MEMORANDUM

Re: Rachel Cohen, 9 Fieldcrest Drive – Clearing, Filling or Excavation Permit
SBL# 41.14-1-17

Date: December 27, 2024

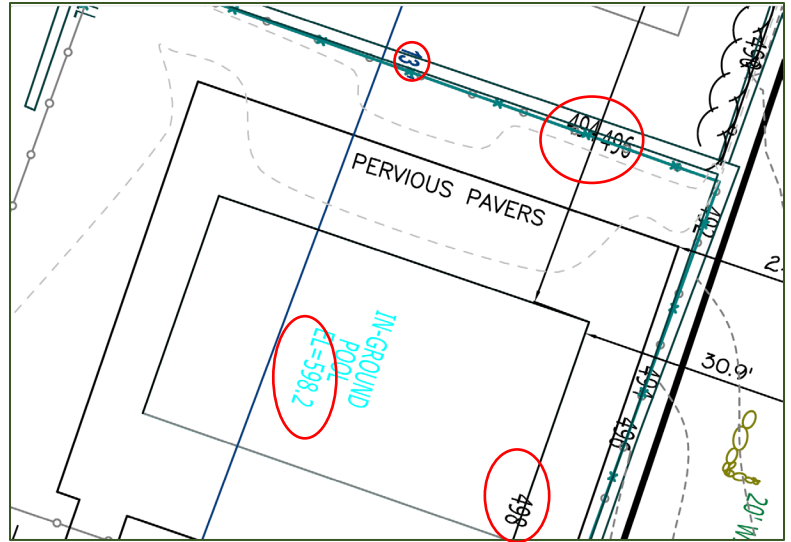
For instance, is the wall between 13 feet high (see closeup below) or 2 feet high? (difference between 496 and 494?) The dashed contour lines around the pool appear to be of the previous grade, rather than the existing finished grade. Also, the elevation of the pool is shown as 598.2 square feet, with the rim of the pool at 498 square feet. **Finished contours appear to be missing south of the pool and basketball court. Please clarify the location of previous and finished contours, with clear labels, with spot elevations for tops and bottoms of walls, which relate to the contours shown.**
